Administrative Approval Action

Case File / Name: ASR-0056-2019
LOT 14 - WESTGATE PARK DRIVE

REQUEST: Development of a 7.145 acre/311,244 sf tract zoned IX-3-PK with Airport Overlay District and SHOD-2 into two proposed Light Industrial use structures totaling 19,000 square feet. Proposed building #1 will be an office use with a gross floor area of 10,000 sf and proposed building #2 will be a 9,000 sf warehouse for storage with storage for fleet vehicles and pallets outside the buildings.

FINDINGS: City Administration finds that this request, with the below conditions of approval being met, conforms to the Unified Development Ordinance. This approval is based on a preliminary plan dated December 13, 2019 by JOHN A EDWARDS AND CO.

A2.01

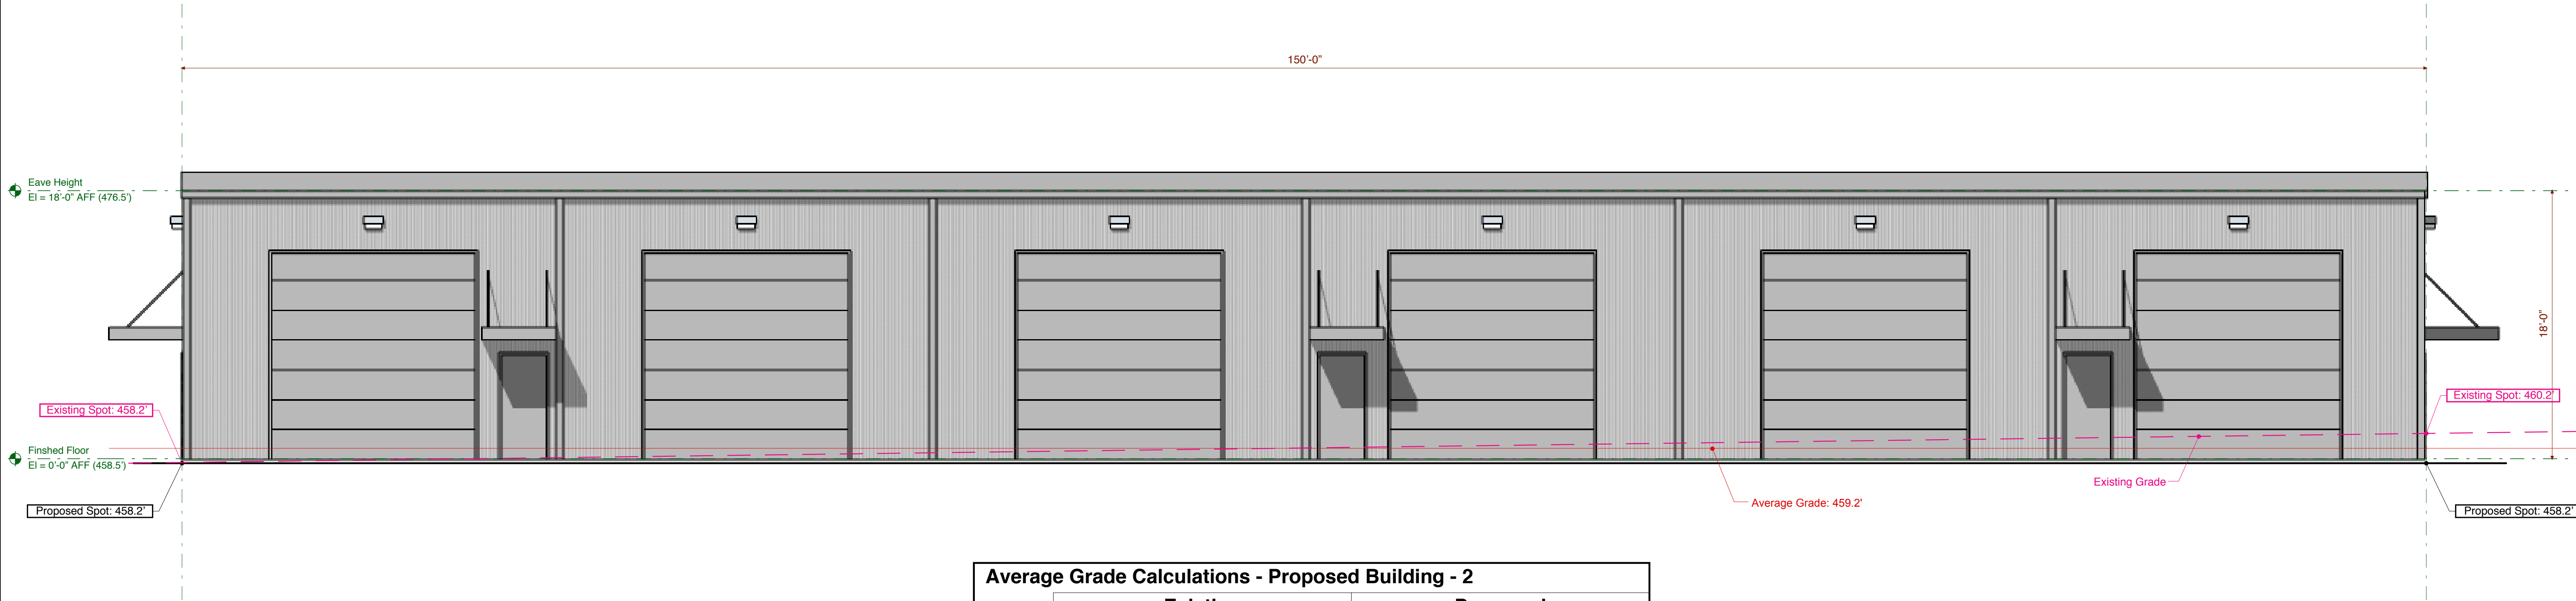
2. On sheet A2.01, Elevations, on the transparency calculations table, the "area of proposed transparency overall" row sf area shall be revised.
3. Elevations Sheet A2.01, on the proposed building #1 illustration, a height measurement elevation distance, for the dashed-blue line marking, shown and delineated across the building facade structure, is provided, labeled by dimension.

5. Elevation sheets A2.01-A2.04, the building height is labeled based on the most restrictive grade(s), as listed on the Average Grade Calculation Tables, is shown as a spot grade on the corresponding building elevations from which the building height should be dimensioned. Not the FFE as indicated on the elevation sheets.

A2.03

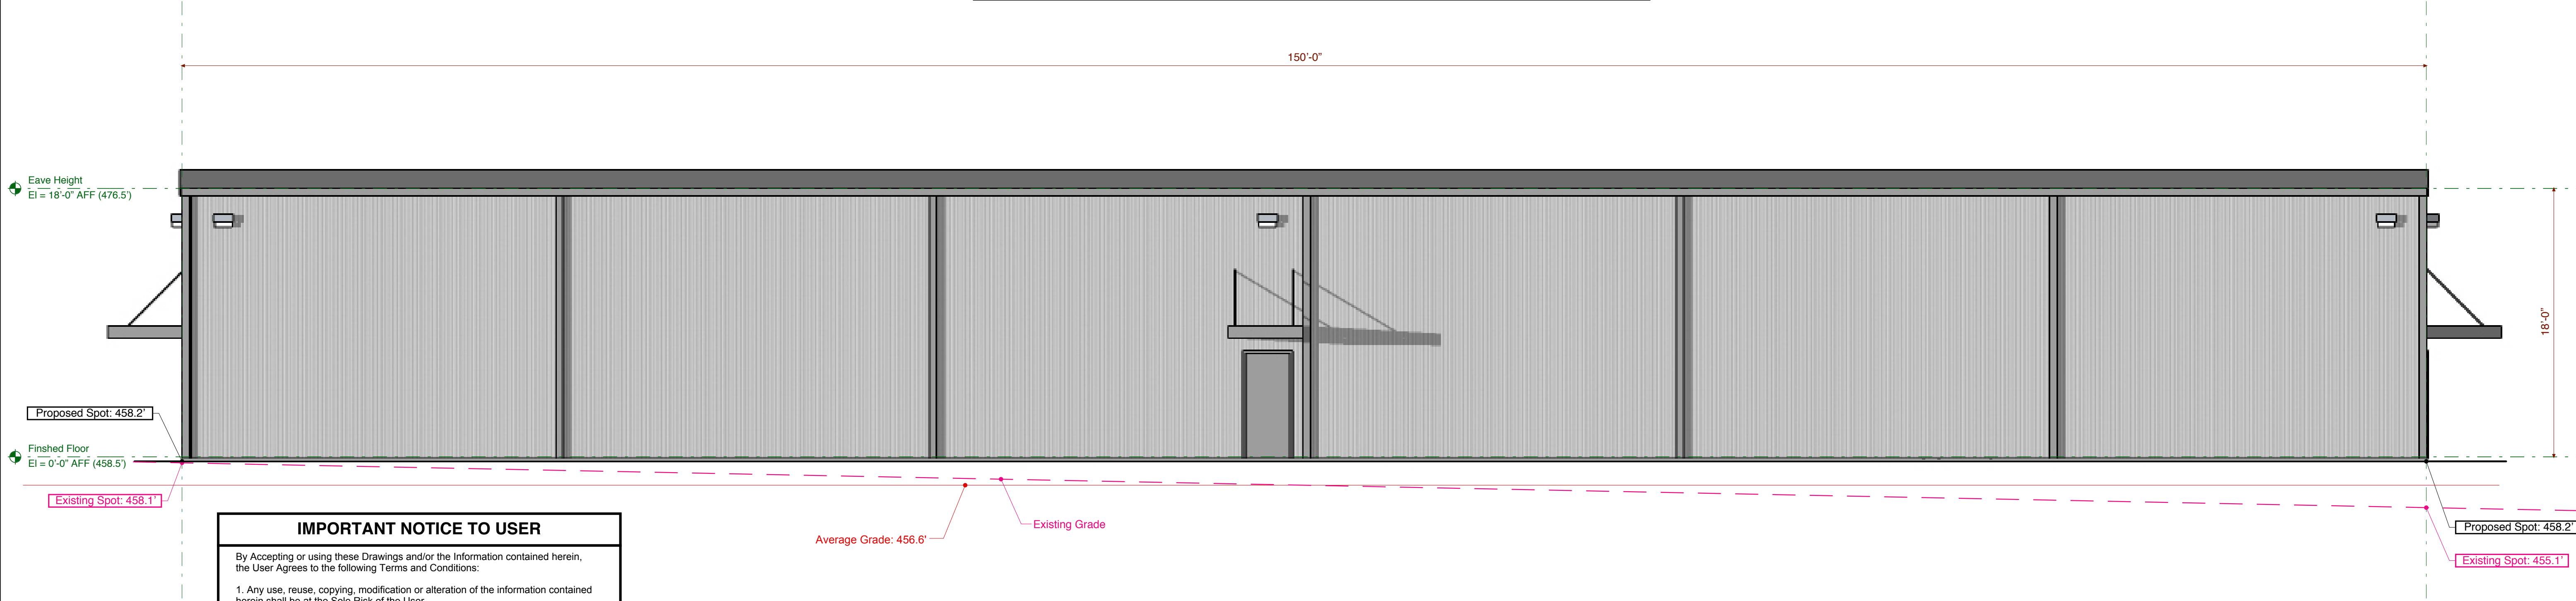
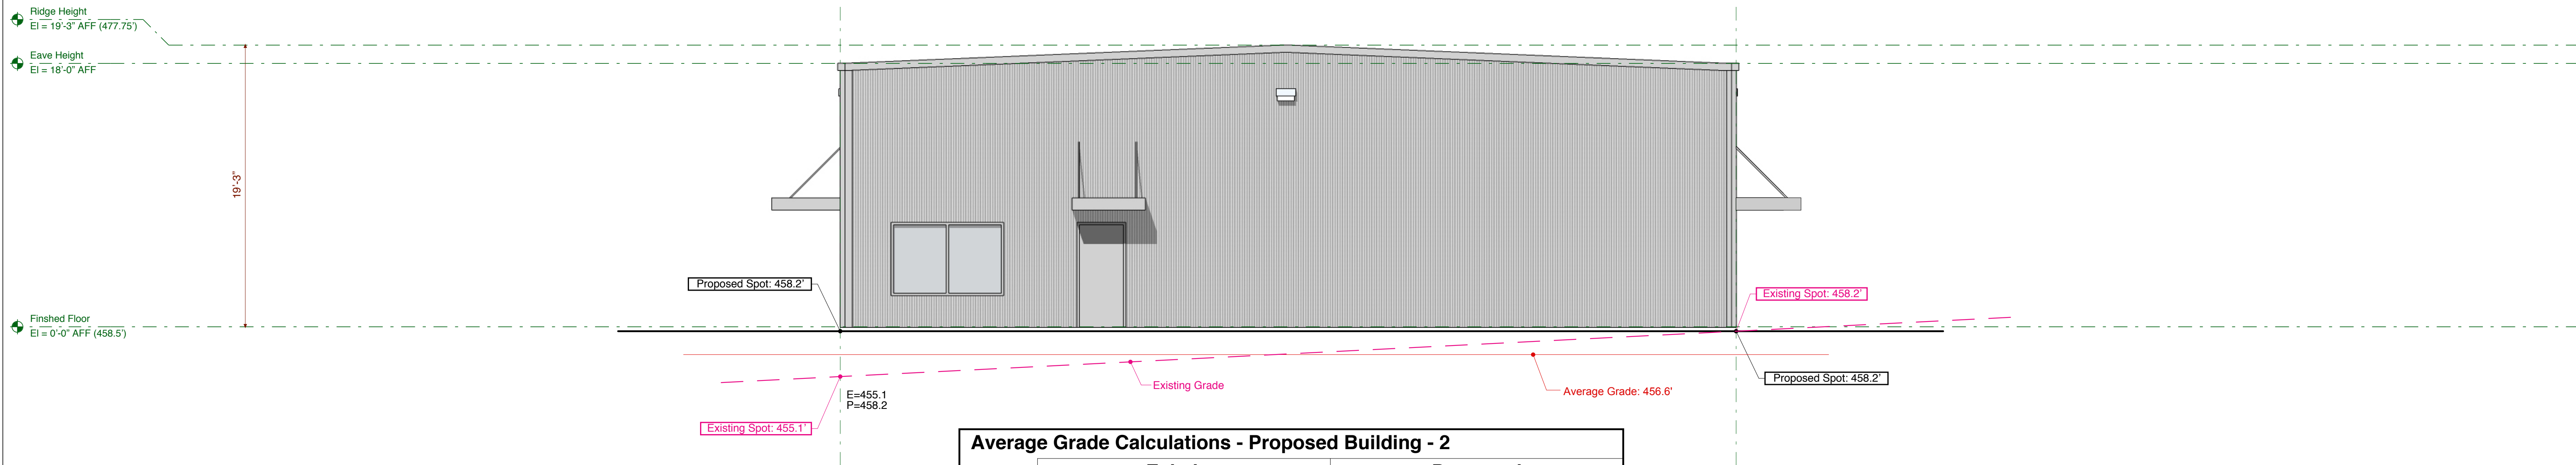
4. Elevations Sheet A2.03-A2.04, revisions to the "proposed" spot grades (458.2'ft) shown on all 4 building plane elevation illustrations, for building #2, are corrected to correspond to the grades listed in Average Grade Calculations Table shown on sheet A2.03 & A2.04 (458.2'ft).
